**RE: BEK Distribution Facility
601 Gallatin Place NW
Grading and Drainage Plan & Drainage Report
Engineer's Stamp Date: 09/06/19
Hydrology File: J10D002G1**

Based upon the information provided in your resubmittal received 09/06/2019, the Grading & Drainage Plan and Drainage Report are approved for Building Permit, Grading Permit, and for action by the DRB on Site Plan for Building Permit.

RE: **BEK DISTRIBUTION FACILITY – 601 GALLATIN PL. NW
D&D PLAN AND DRAINAGE REPORT ENGINEERS
STAMP DATE 07/19/2019, HYDROLOGY FILE: FJ10D002G1**

Revision No. []
 Job No. 2018014
 CAD/CHK'D By: pm / vc
 Date: 8-16-19
 Sheet Title: GRADING AND DRAINAGE PLAN
 Sheet No. C203
CIVIL

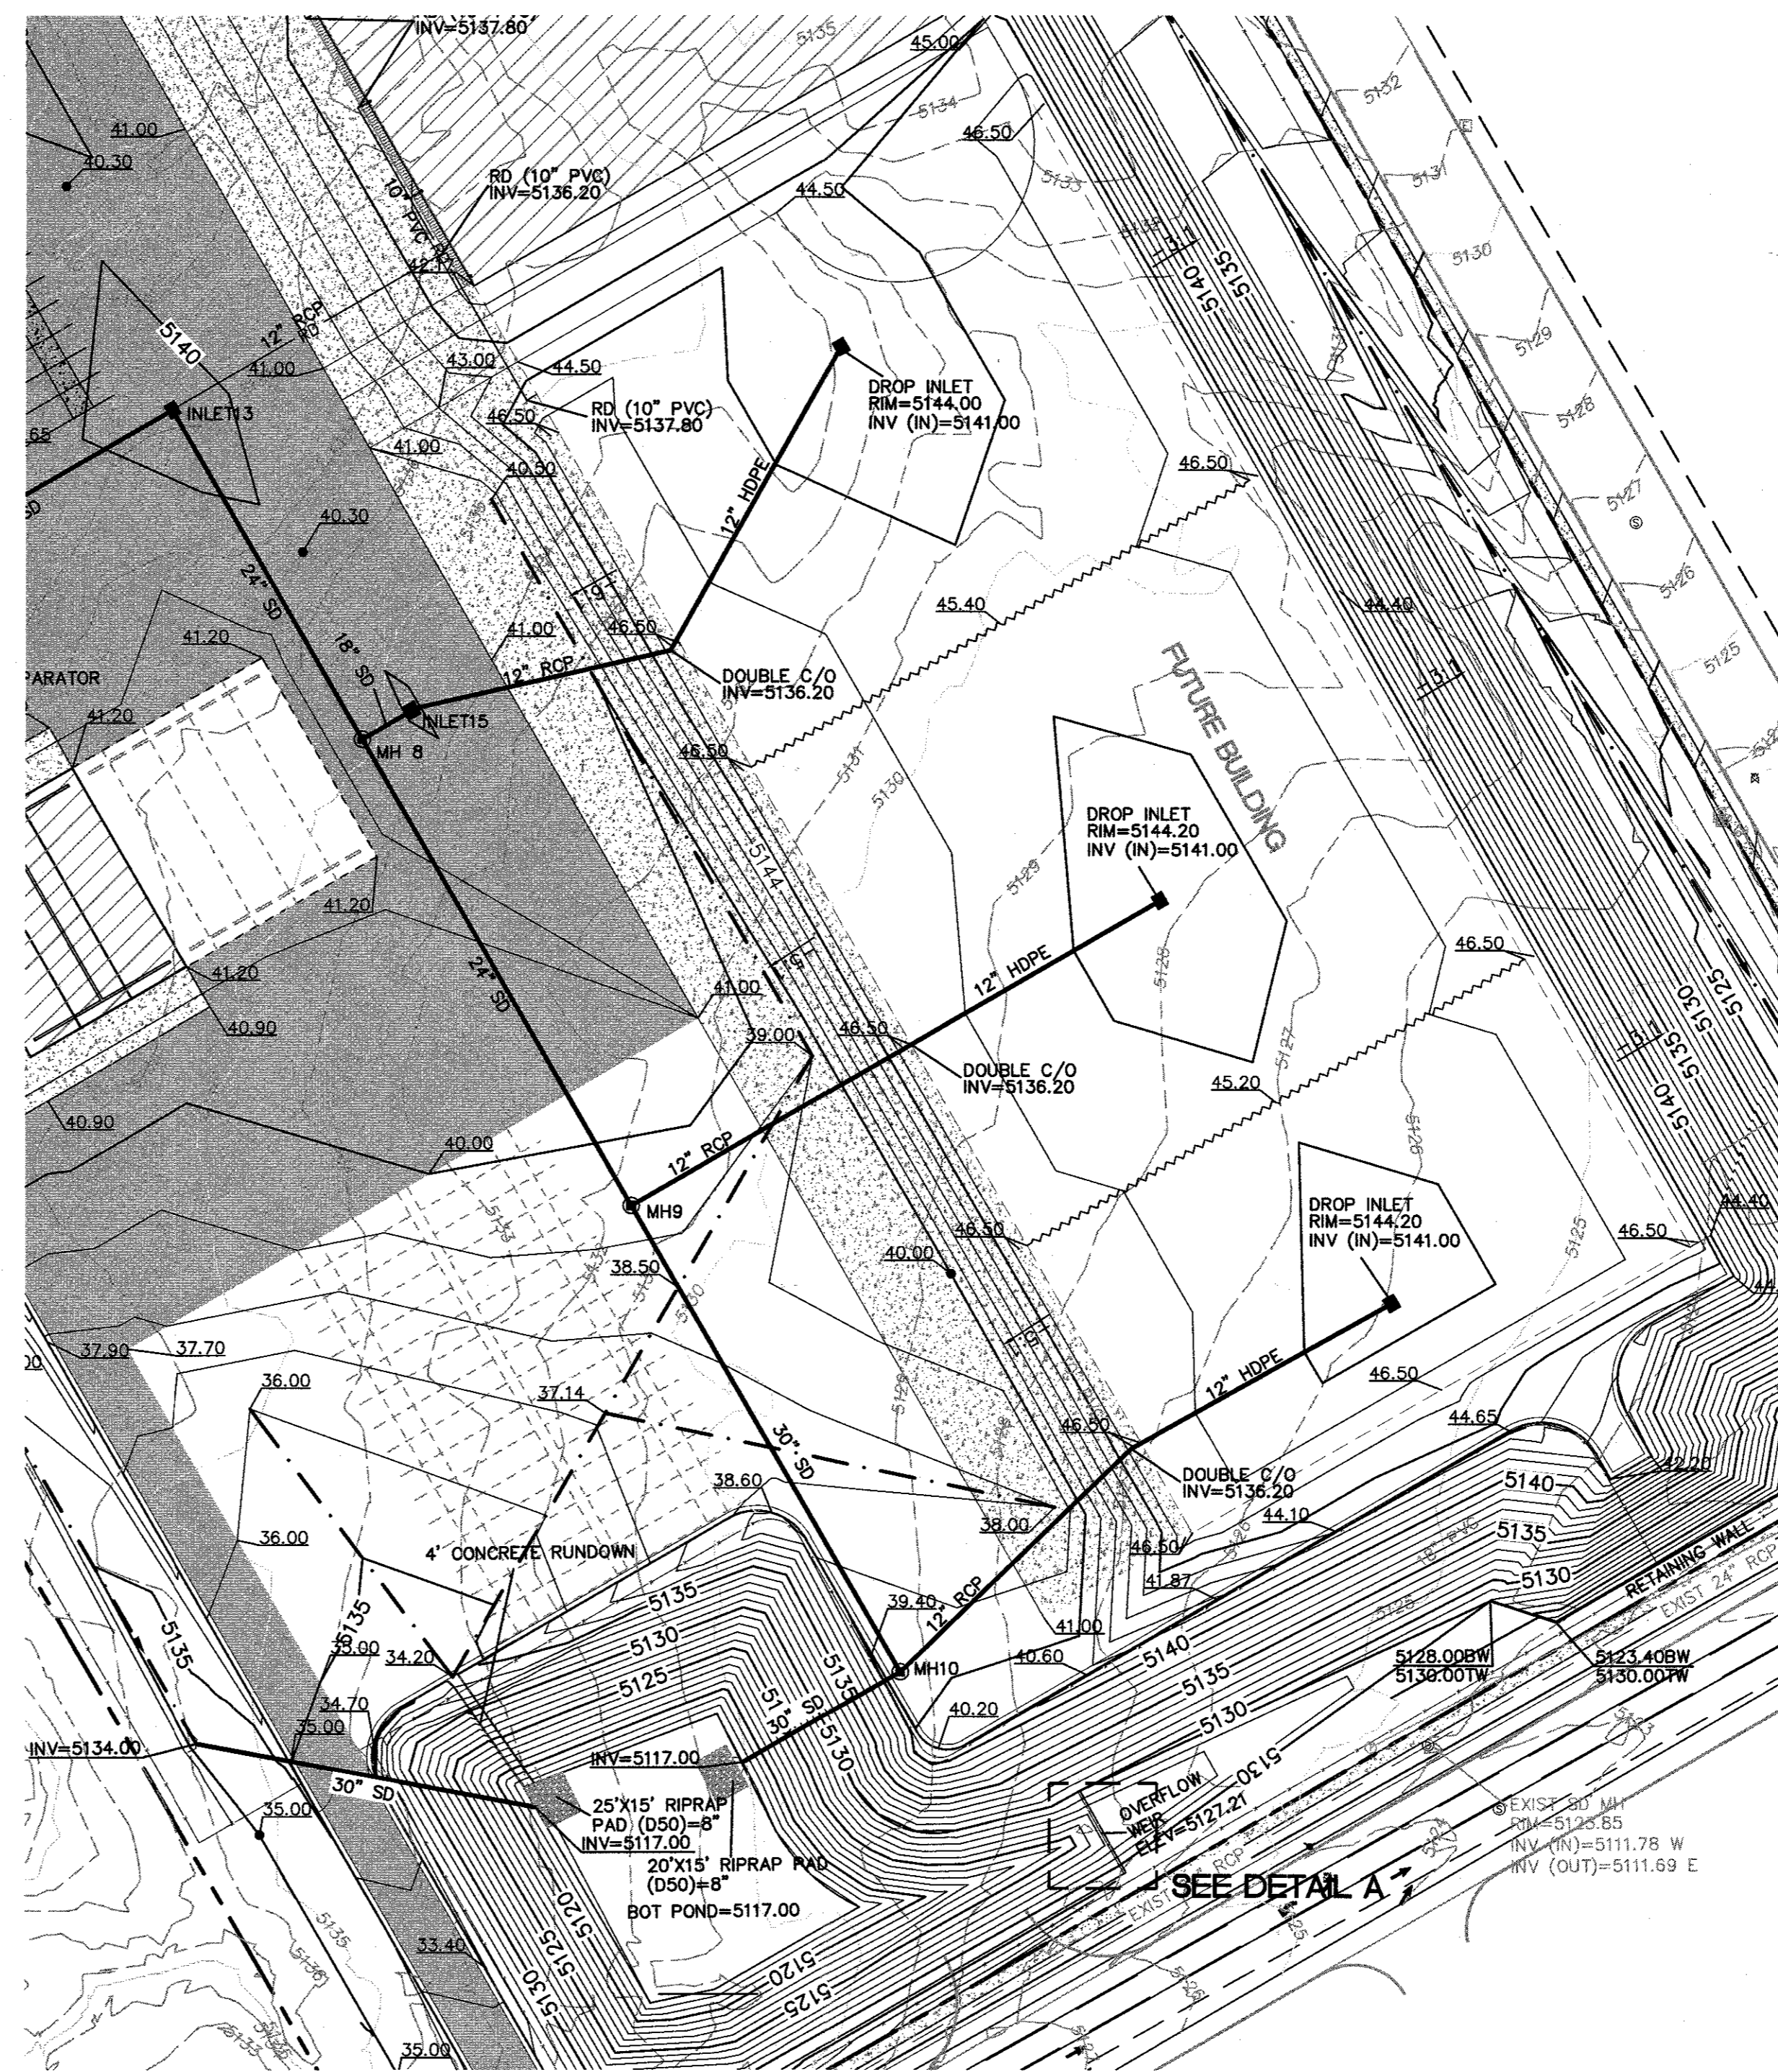
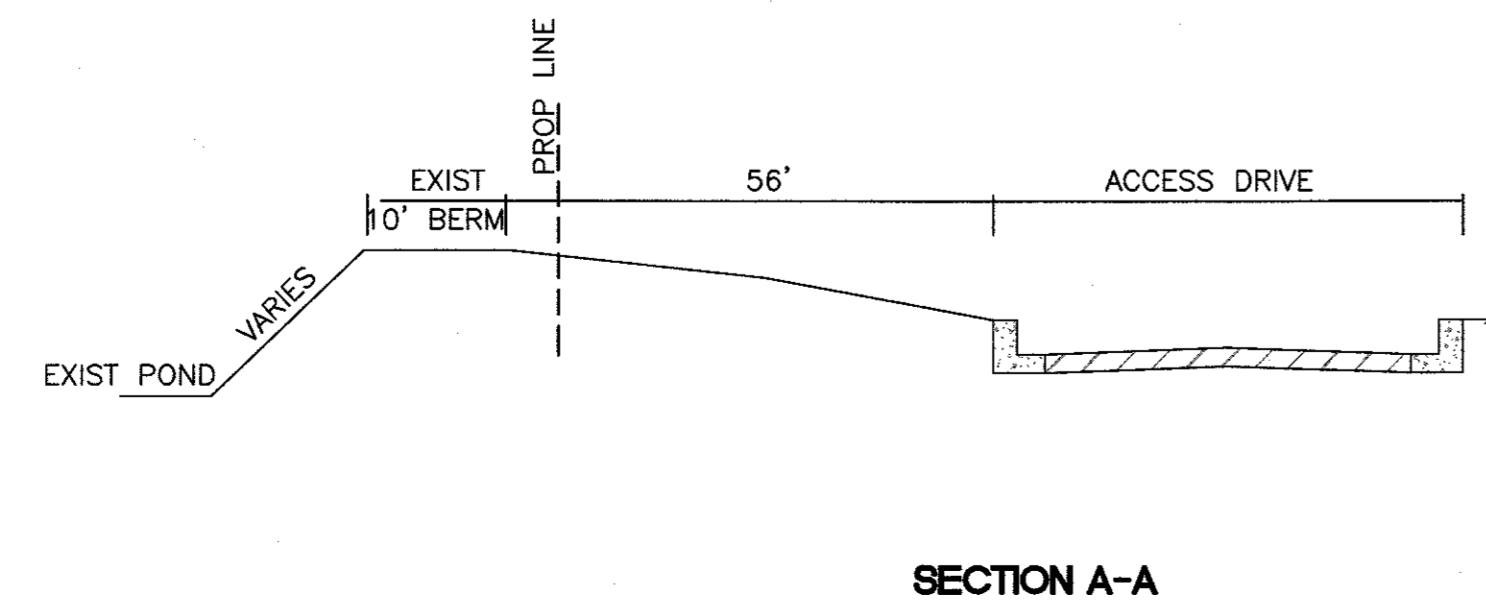
- b. Better survey information must be added to the G&D Plan including detailed survey of the dam, the headwall and pipe outfall, and the emergency overflow spillway. A detail of the emergency overflow spillway connection to the new sidewalk culvert must be provided

- c. The existing Dam may encroach on this site. A minimum 6' wide top of dam must be maintained. Section A-A on sheet C203 may need to be updated with the results of the revised survey and hopefully get the dam off of the BEK property and back onto the Coca-Cola property.

9. Please show the PNM easement adjacent to and on this tract in the west corner. Either revise the plan to eliminate the grading within the easement or provide written permission from PNM for grading inside of their easement.

10. The finish contours are missing between the retaining wall and the street in Los Volcanes Road. Please show proposed contours all of the way to the existing street to indicate the proposed grade of the sidewalk. Also please add a few typical sections showing the grade on both sides of the retaining wall, the new sidewalk, the ROW line, the fence, and the slope.

Response: Additional survey information was attained and included in the drawings showing the existing outfall culver and headwall, the existing overflow structure and the dam / berm(s). A detail of the existing and proposed revised overflow structure has been added to Sheet 203.

Response: The additional survey information attained shows the existing dam / berm with a minimum 10' berm, which is maintained under the proposed BEK improvements.

Response: The PNM easement in the west corner of the site, adjacent to Unser Blvd right of way is now shown on Sheet C203. The proposed grading does not encroach on the existing PNM easement.

Response: The finish contours were added in the noted area on Sheet C203. Typical sections of this area are shown on Sheet C213, Section G.
11. HGL calculations are required for the storm drain in the north east corner of the site where failure of the storm drain could result in excessive storm water runoff to public streets. Also please add a profile and HGL calculations for the storm drain on the south and east side of the building.

DETAIL A

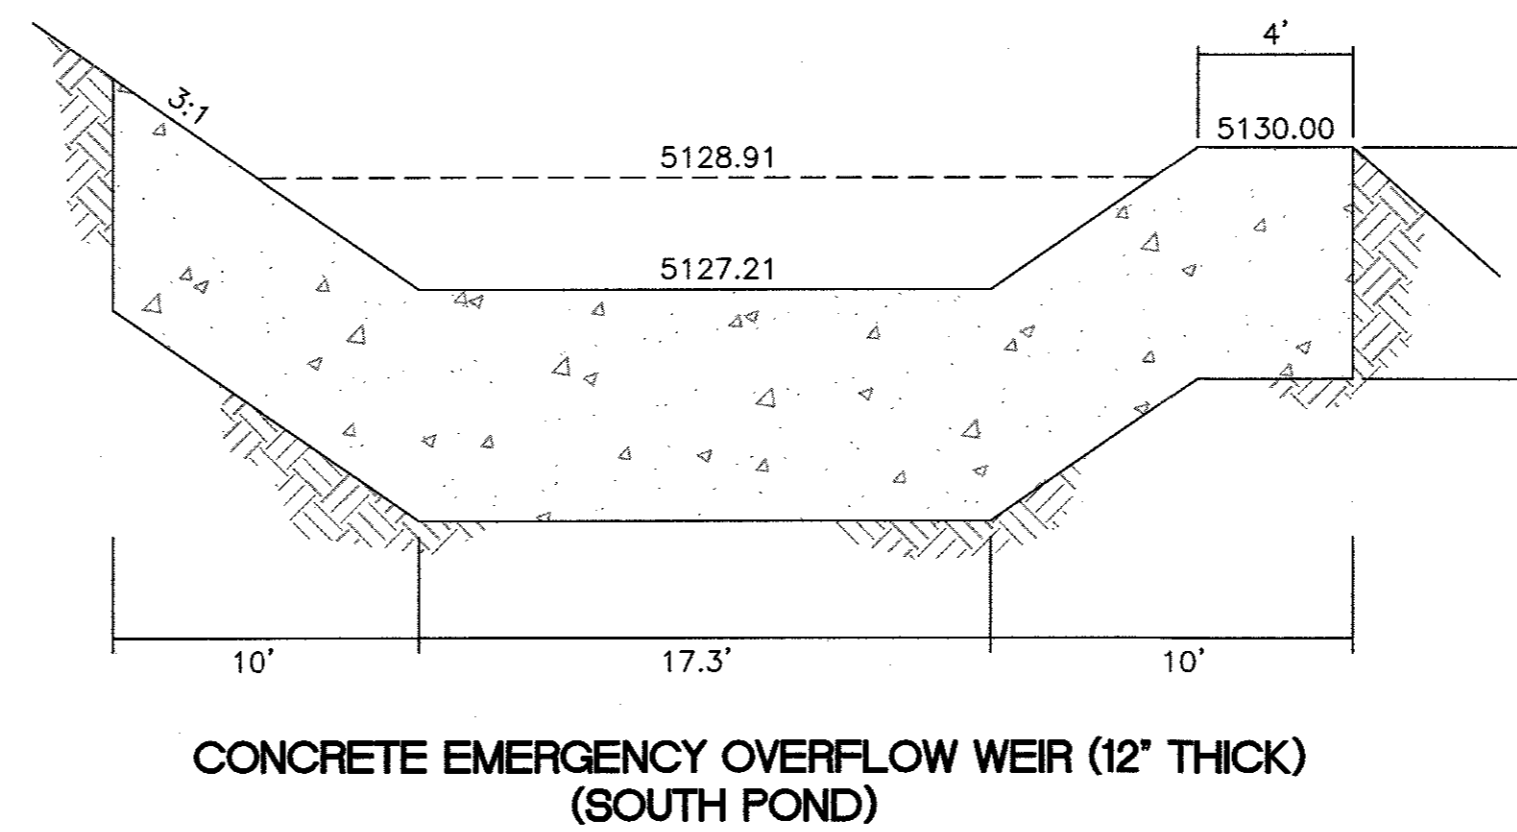
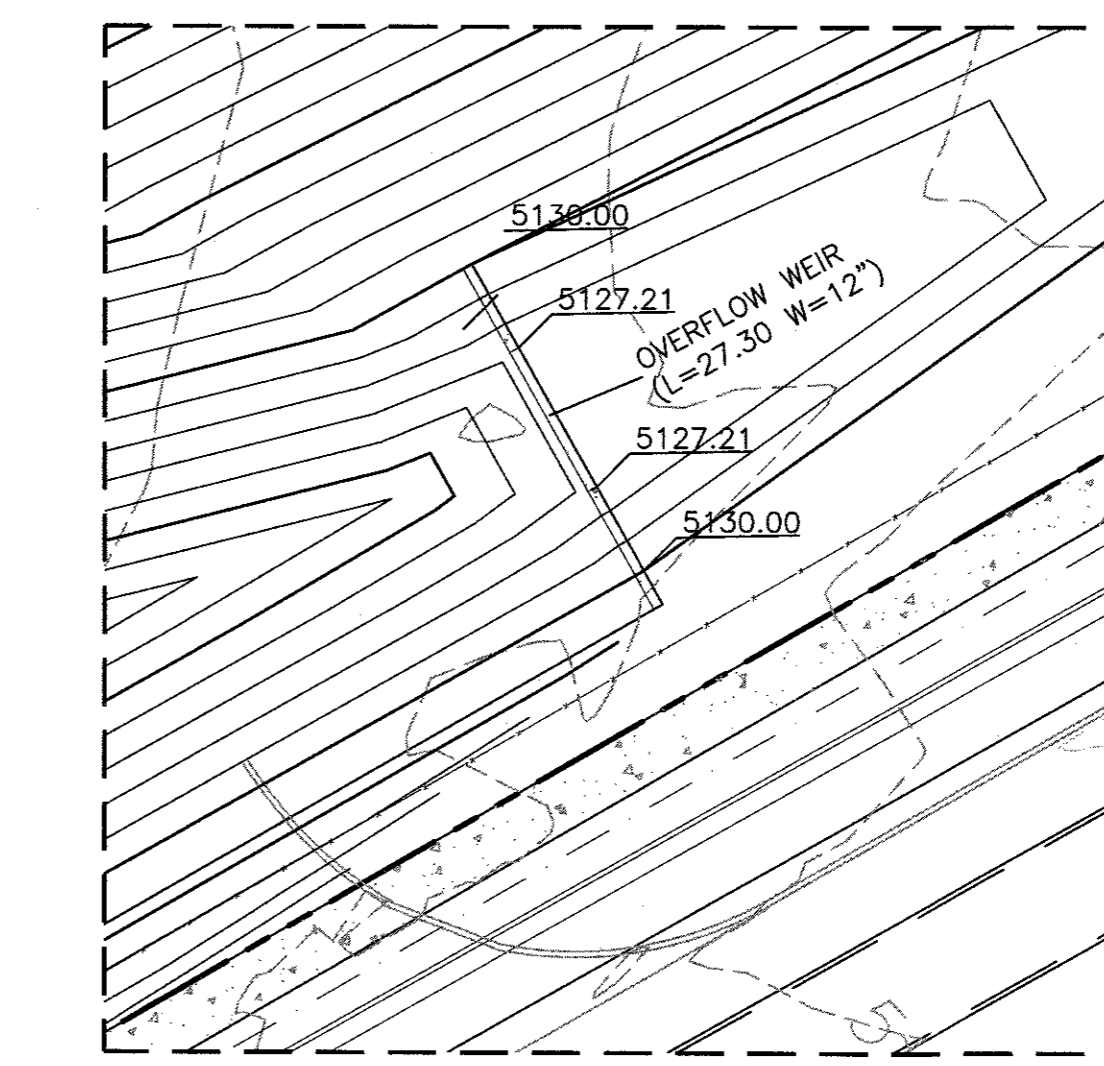
13. The south pond must have a non-erosive spillway. Please add a build note and a detail on the G&D Plan. Please check the weir coefficient, 1.6 is for metric units, 2.7 is SI for broad crest, and 3.3 SI for sharp crest.

Response: A concrete emergency overflow structure and detail were added to the south pond on Sheets C203 & C204. Calculation of broad crested weir is $Q=1.6LH^{3/2}$, where Q is in cfs, L is in ft and H is in feet.

Revision No.	△
Job No.	2018014
CAD/CHK'D By.	pm / vc
Date	8-16-19
Sheet Title	INTERIM GRADING AND
Sheet No.	C205
	CIVIL

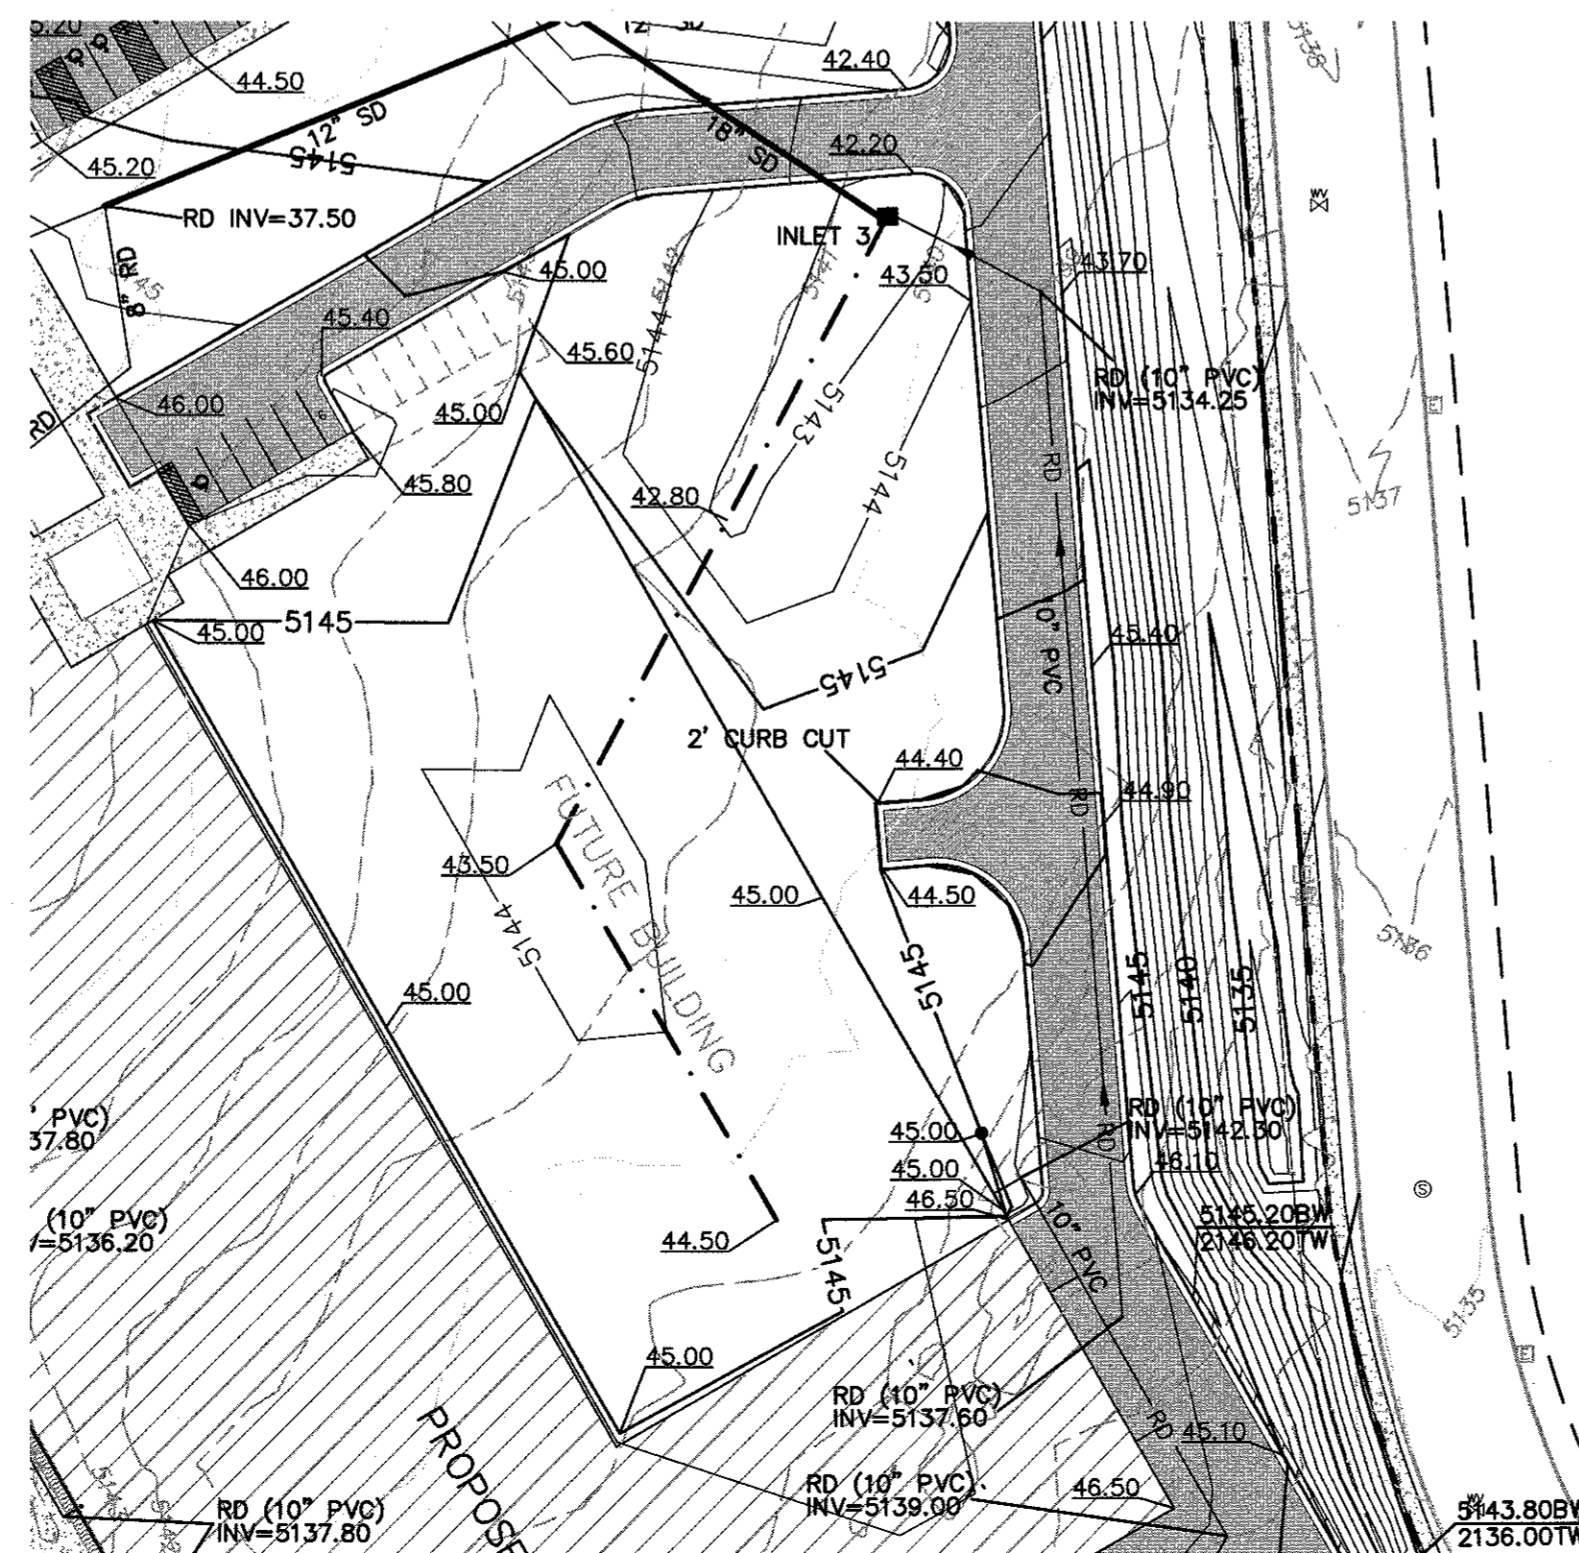
3. Key note 25 on the Site Plan calls for a 6" temporary header curb that is not shown on the G&D Plan. Please revise on or the other so they agree, and provide a copy of the revised Site Plan when resubmitting to hydrology. If the temporary curb is to remain please add details of the curb on the G&D Plan with spot elevation that show how the parking lot will drain thru the curb.

16. It appears that curb opening details and design calculations may be missing. Please identify how the drainage from Basins 8 and 9 gets into Inlet #3. Also please identify how the drainage from basin 24 gets into the south pond by including details on the G&D Plan and calculations in the report. The engineering design analysis must demonstrate that the peak 100 year flow rates are intercepted by onsite drainage structures and prevented from entering the public right of way.

Response: The 6" temporary header curb (per COA Std Details) is now called out on Sheet 205 of the grading plans to agree with what was approved on the Site Plan. The existing and future auto parking fields drain via surface flows generally from south to north. Curb cuts will be provided in the proposed temporary header curb as noted on Sheet 205 to allow the runoff from the first phase parking field to continue flowing north where it will be captured in a swale and enter a rundown into the north retention pond.

Response: Design calculations have been added to the G&D report. The runoff from the building areas in Basins 8 & 9 are proposed to at the roof drains and conveyed to Inlet #3 in a storm drain. Profiles for the storm drains are now included on Sheets C206 & C210. Under interim conditions, the future building area in Basin 8 will sheet flow to Inlet #3 as is shown on interim grading Sheet C205.
